### Addendum Number 02

Project	Ramsey - Baske	etball Locker Roon	n	Dat	e 11/3	30/2021
Project Location	92 Catamount F Cullowhee, NC 2			Arc	nitect's P	roject Number 09.9478.000
Owner / Client	Western Carolin	a University		File	A2	This is page 1 of 2
То	Western Carolin	a University, Faci	lities Management	Atte	ention	Daniel Fiskeaux
Address	3476 Old Cullov	vhee Road				
City	Cullowhee			Stat	e NC	Zip 28723 Code
Delivered via:	🗌 Me	ssenger 🗌	Hand carried	☐ Facsim	ile	
	🗌 Exp	oress 🗌	Pick-up	🛛 E-mail	Address	
	🗌 Ma	ii 🗆	UPS	🗌 Websit	e Addres	S
any of the Work of all re Addendum supersede of	levant contents of thi nly those conflicting is	s Addendum. In case o sues. It is the respons	of conflicting provisions vibility of the Contractor	with previous a to notify all su	addenda o Ibcontract	nd all others performing or supplying or communications, provisions in this fors from whom it accepts bids of all Idendum number and its date in the

Addendum 02 forms a part of the Contract Documents for the above referenced project. The following specifications are revised to capture the questions in RFI1. The following drawings are added and revised to capture the questions in RFI1, updated door f

Project Name **RAMSEY - BASKETBALL** LOCKER ROOM RENOVATION Project Number 009.9478.000 Description INTERIOR ELEVATIONS OF FILM ROOM Scale 1/2" = 1'-0" **I1.101**

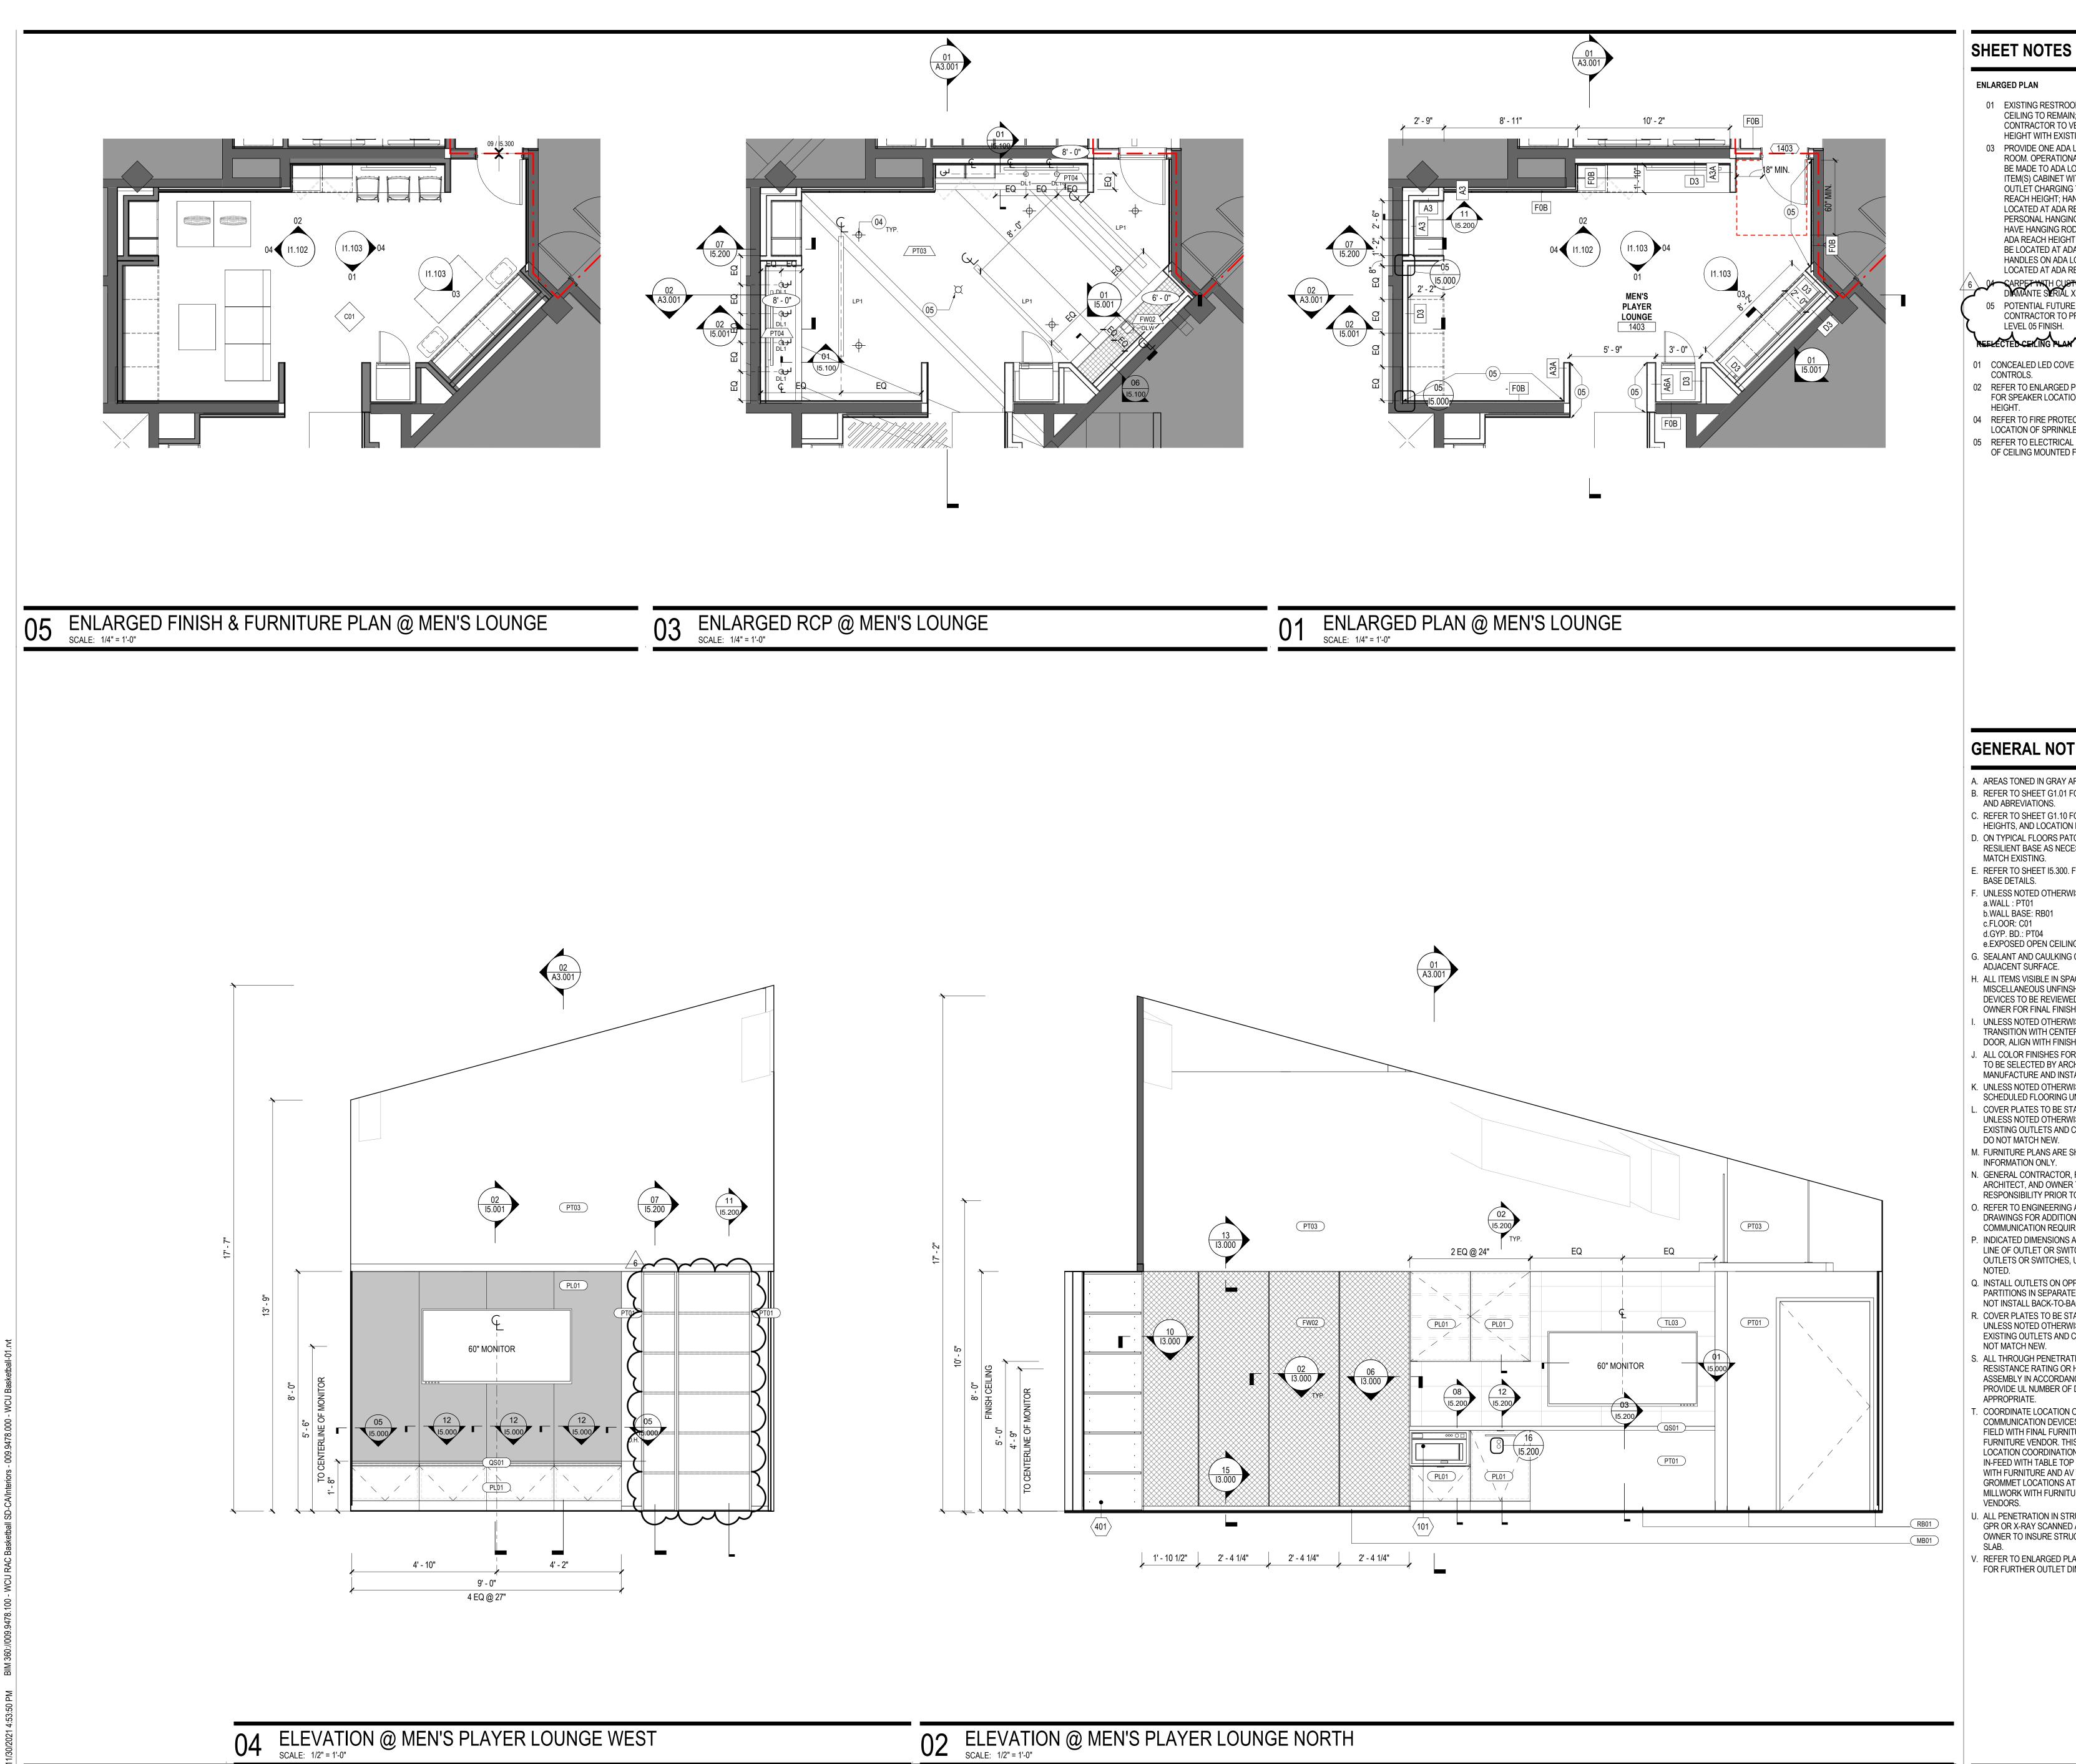
4	11/23/2021	Brantley Construction Company	The countertop shown on 03/11.101 is noted as solid surface on the elevation (QS01) but section 03/15.200 shows this as a plastic laminate countertop. Which is correct?	Countertop to be solid surface (QS01). Refer to update on Section 03/I5.200.	Gensler	11/30/2021	AD02
5	11/23/2021	Brantley Construction Company	The countertop shown on 02/11.102 is noted as solid surface on the elevation (QS01) but section 03/15.200 shows this as a plastic laminate countertop. Which is correct?	Countertop to be solid surface (QS01). Refer to update on Section 03/I5.200.	Gensler	11/30/2021	AD02
6	11/23/2021	Brantley Construction Company	Acrylic Panel @ lockers, displays?	Acrylic panels are part of the locker manufactures scope.	Gensler	11/30/2021	AD02
7	11/23/2021	Brantley Construction Company	There are two carpet options noted on I1.104 (note 09) but this is not reflected on the bid form. If this alternate is required please provide a revised bid form.	See updated bid documents per add alternate.	Gensler	11/30/2021	AD02

Project Name **RAMSEY - BASKETBALL** LOCKER ROOM RENOVATION Project Number 009.9478.000 Description INTERIOR ELEVATIONS OF WOMEN'S LOCKER AND LOUNGE Scale 1/2" = 1'-0"

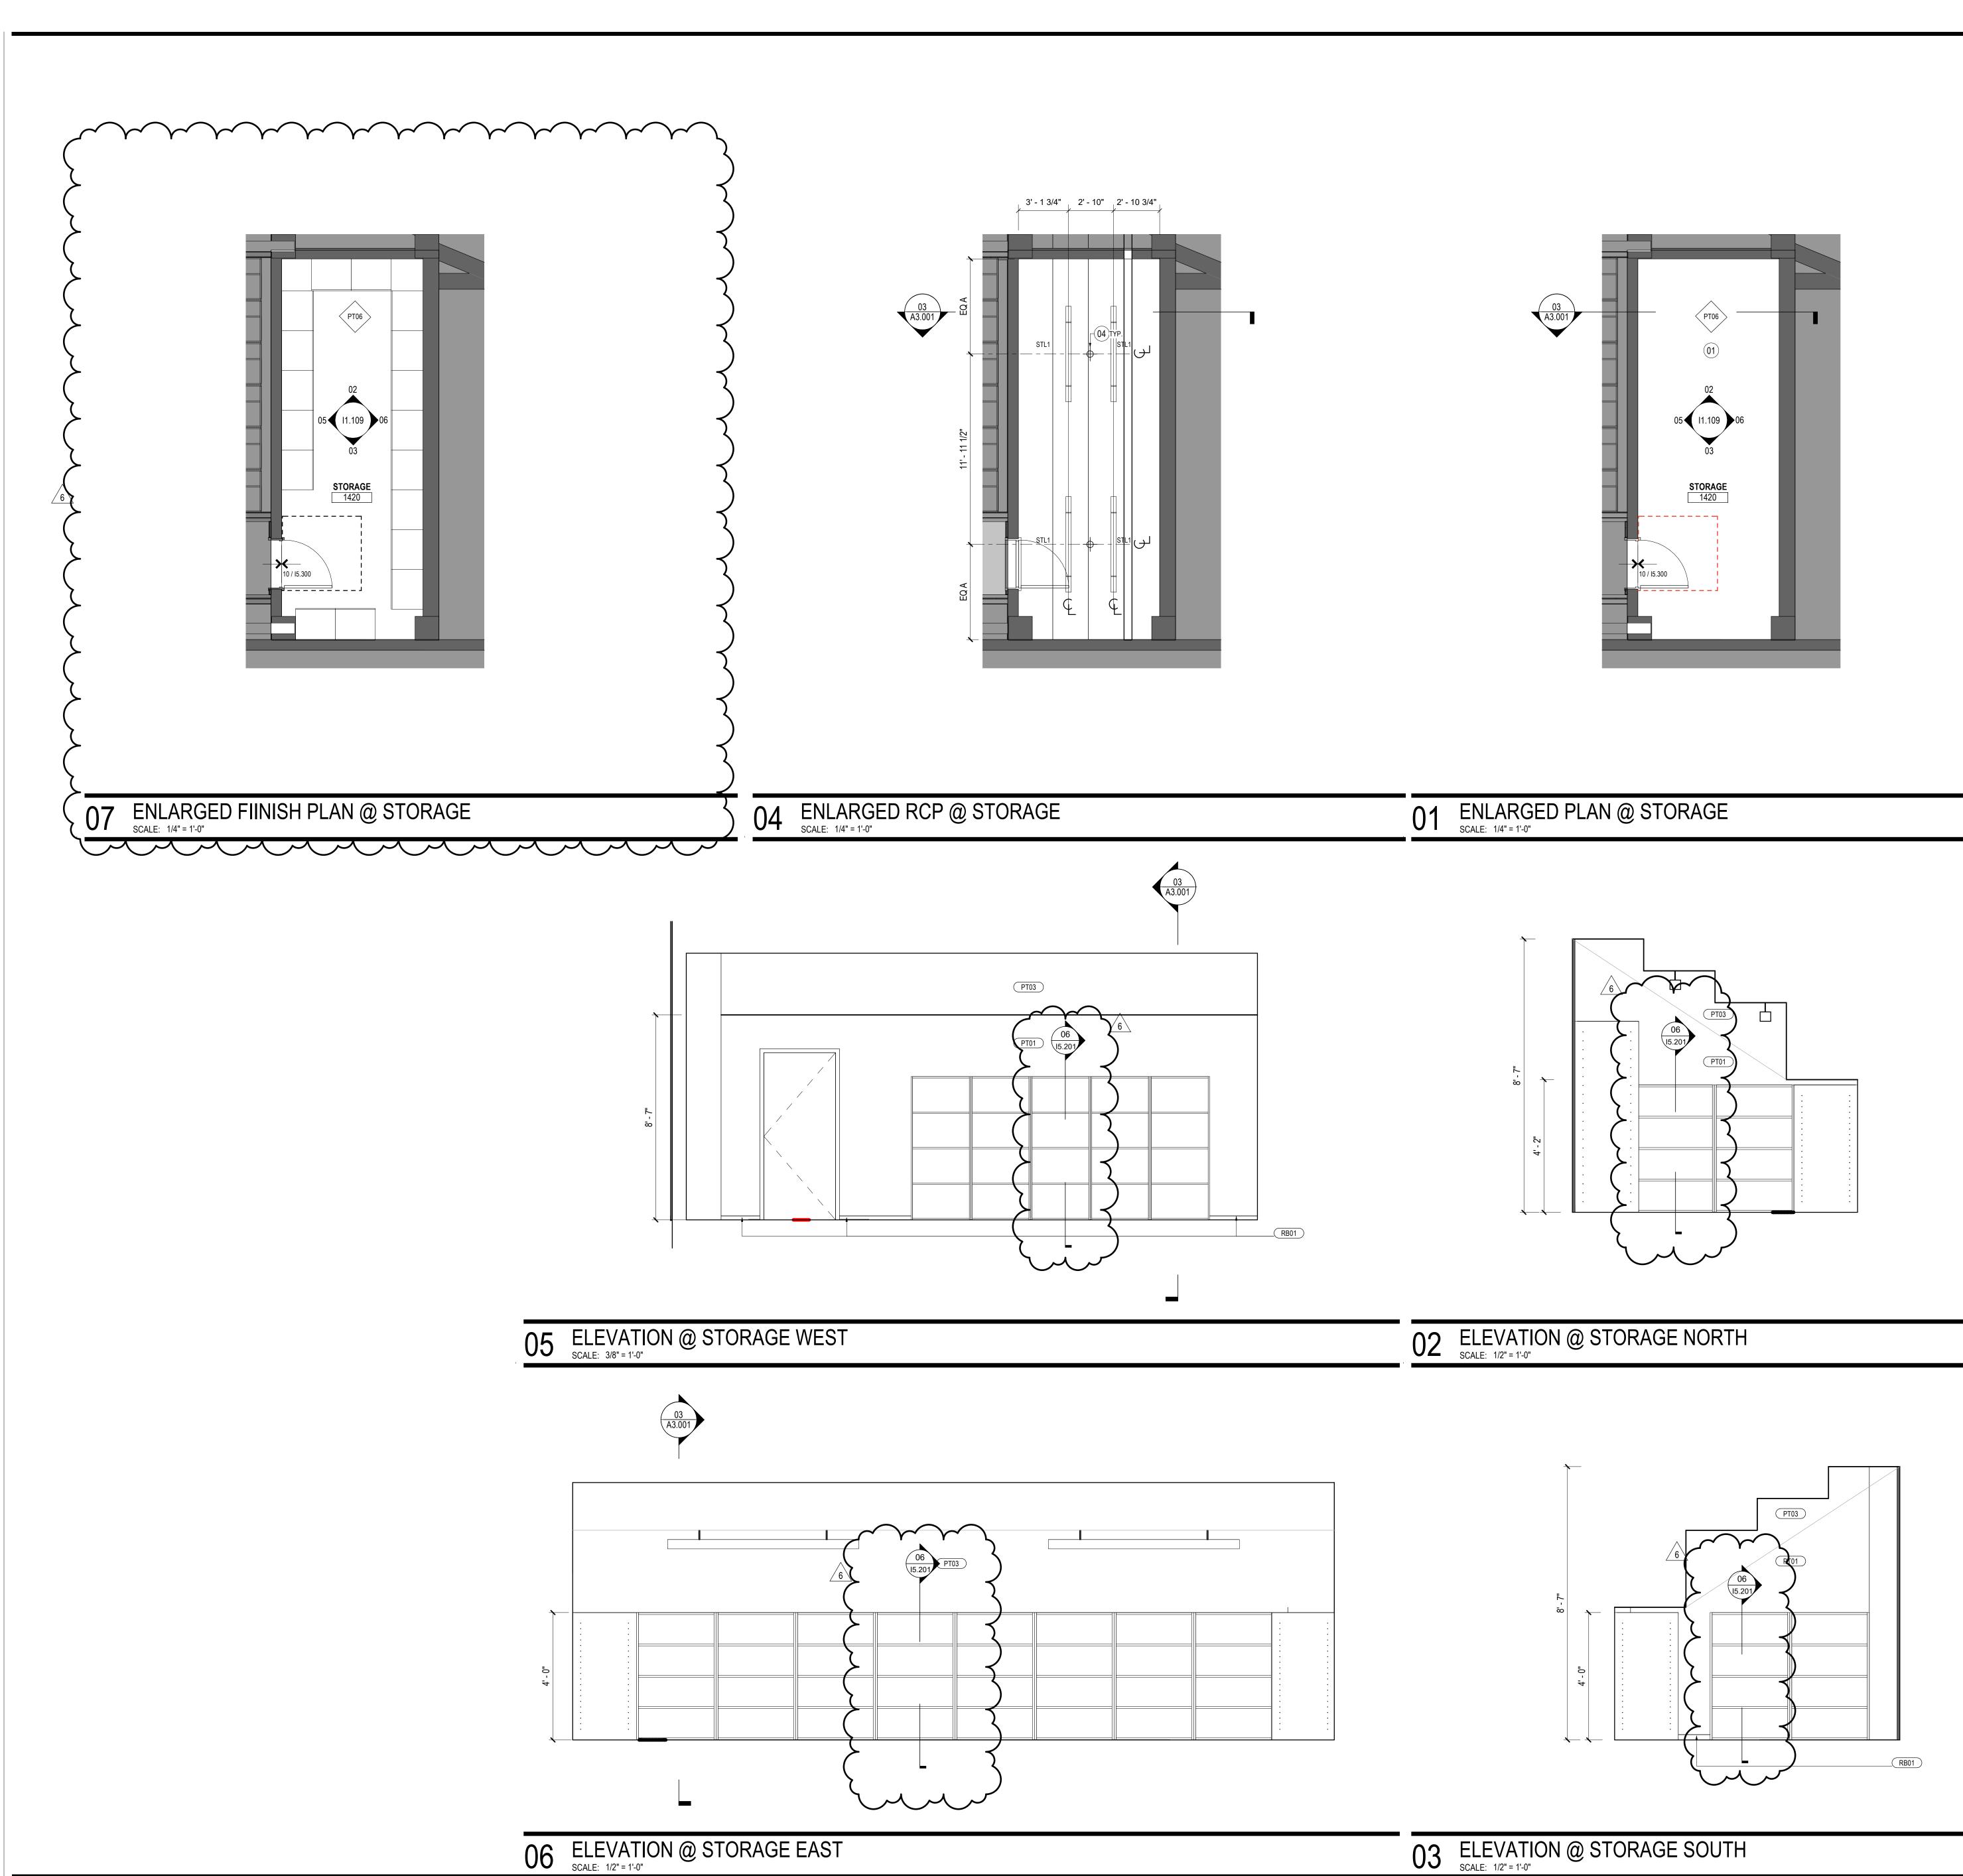
8	11/23/2021	Brantley Construction Company	There are two carpet options noted on I1.106 (note 08) but this is not reflected on the bid form. If this alternate is required please provide a revised bid form.	See updated bid documents per add alternate.	Gensler	11/30/2021	AD02
